# Oregon State University

## **HOVLAND HALL WEST WING REMODEL CONSTRUCTION SERVICES**

### **ADDENDUM NO. 2**

## Addendum # 03

LEGENDS - NOTES -  
ABBREVIATIONS - WALL  
ASSEMBLIES

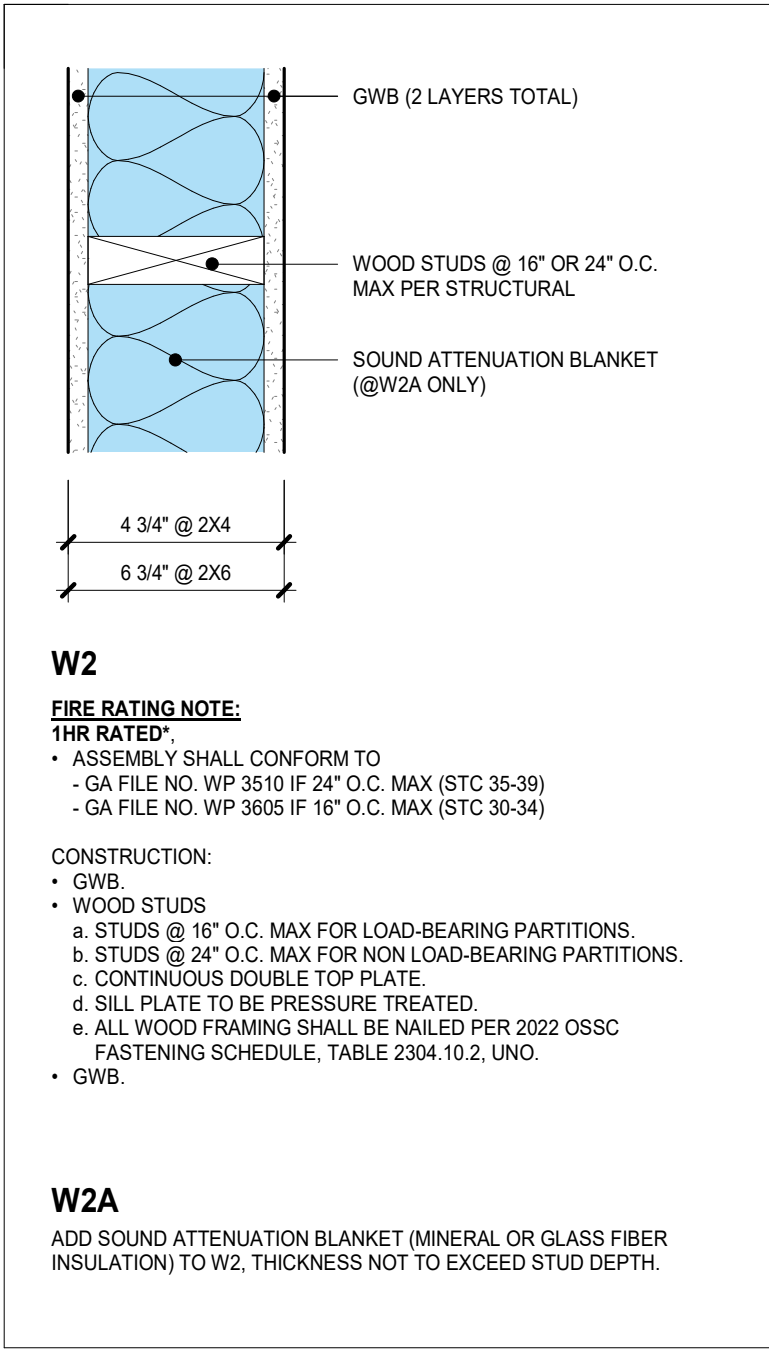
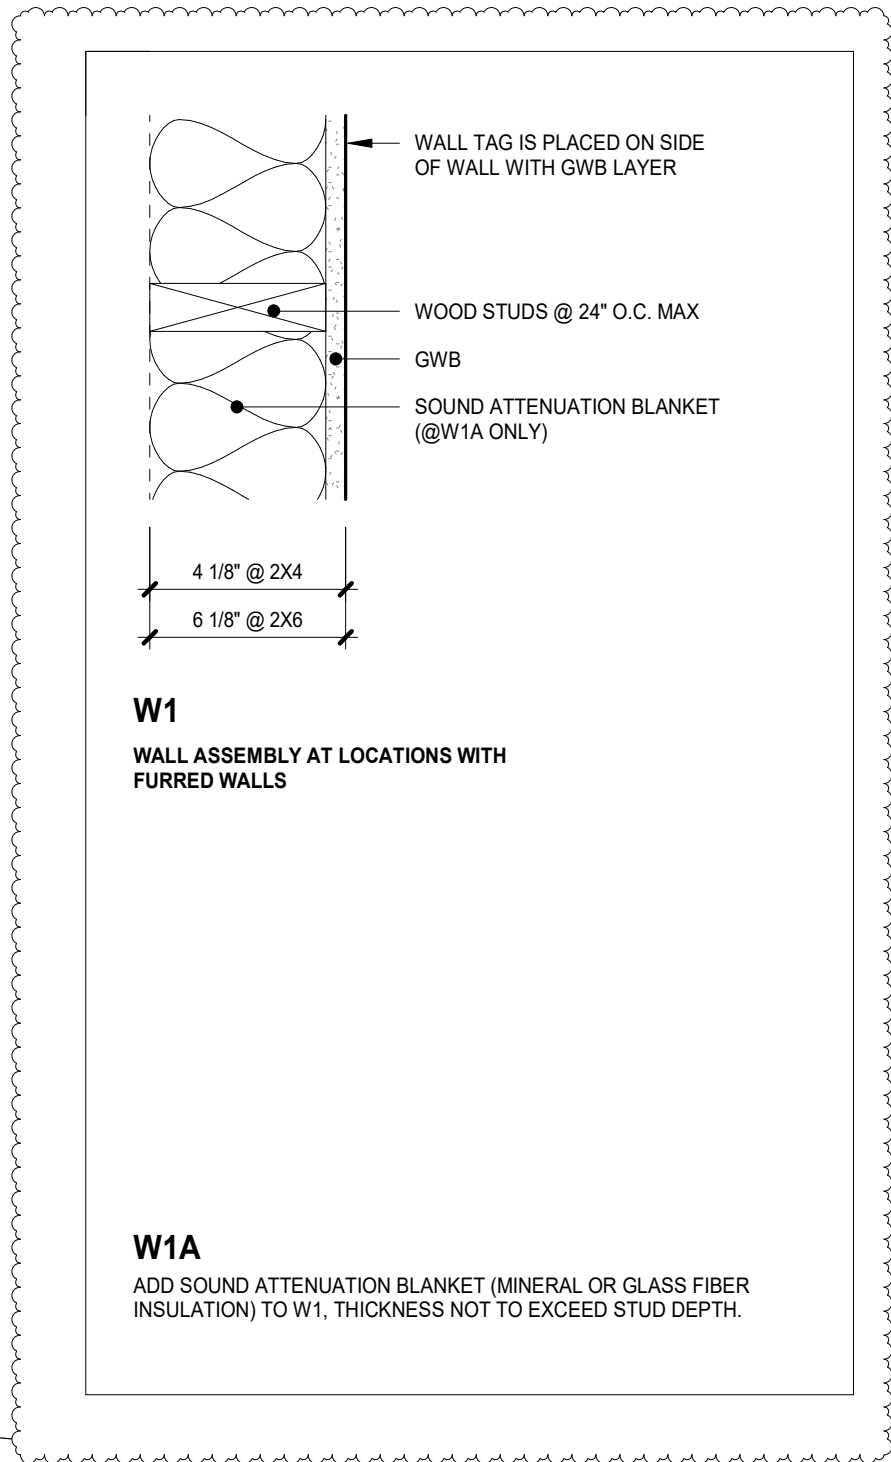
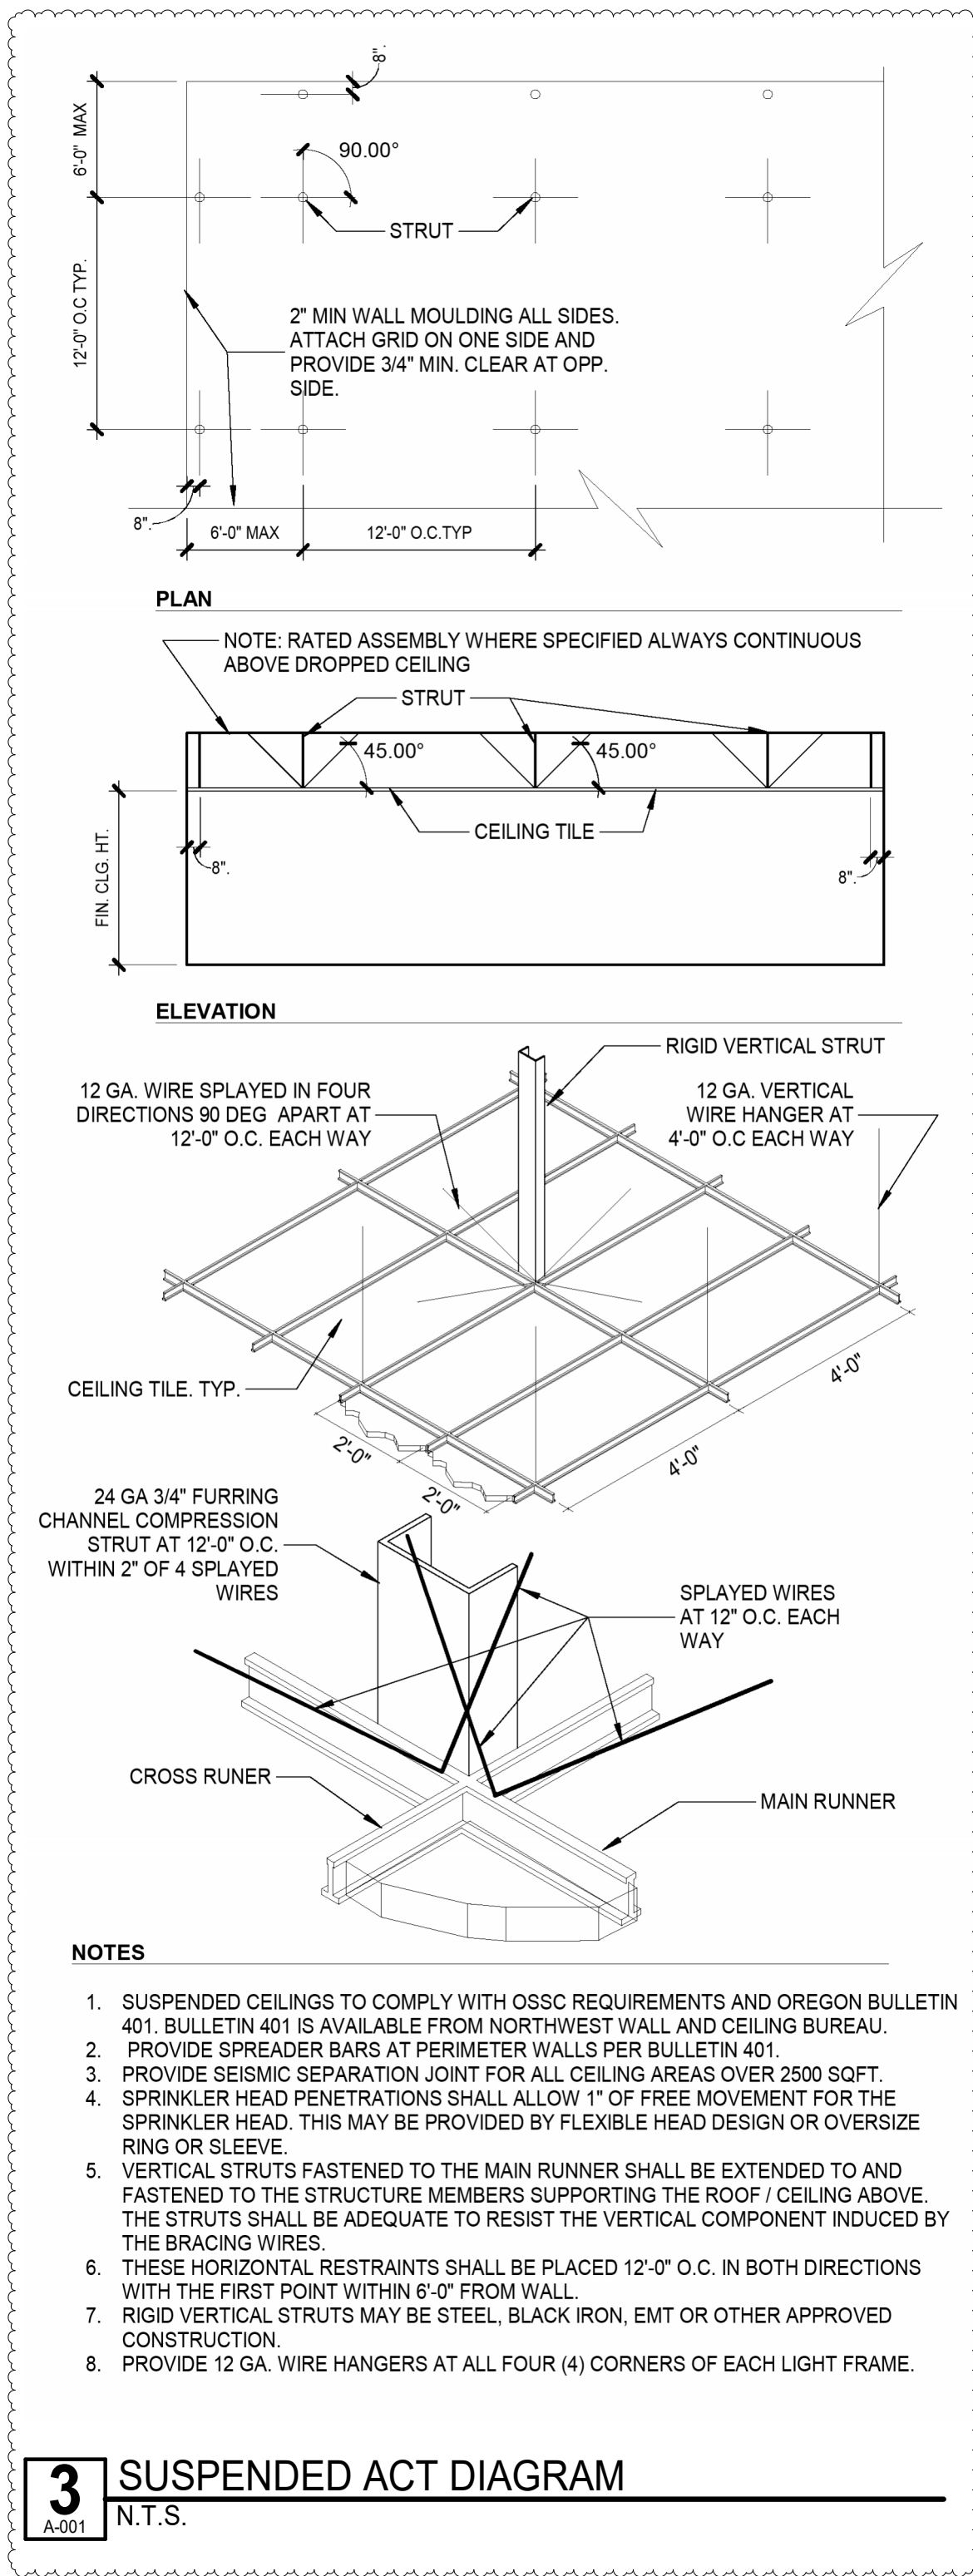
21	3/A-111 indicates floor leveling and concrete pourback. Is there an available estimated slope grade % to trenches for quantifying floor leveler?	Please see revised keynotes A-005 and A-006 on A-111. Finished floor slopes should be installed to ¼" per foot max. Existing trench drains can be assumed to be -4" below the finish floor elevation, for the purpose of estimating floor levelling amounts. This shall be field verified by the Contractor.
22	Will trenches (Keynote A-006/A-111) require de-commissioning and infill as well?	Please see revised keynote A-006 on A-111. Existing trenches have been decommissioned and filled. However, the Contractor shall plug any existing drains which are exposed during below-slab work.
23	A-001 indicates interior wall types as wood framed (W2 and W2A). Addendum 1 1/A-111 calls out wall type W1. Please provide wall assembly for Wall Type W1.	Please see revised sheet A-001 with added wall type.

- 5) Sheet A-001 (re-issued, attached). Revisions include:
  - a) Framing size notes revised as shown.
  - b) Wall type W1 / W1A added as shown.
  - c) Drawing #3 Suspended ACT Diagram added as shown.
- 6) Sheet A-111 (re-issued, attached). Revisions include:
  - a) Keynotes A-005, A-006 and C1 revised as shown.
- 7) Sheet A-601 (re-issued, attached). Revisions include:
  - a) Keynotes revised as shown.
  - b) Elevation 17 revised as shown.
- 8) Sheet P-002 (re-issued, attached). Revisions include:
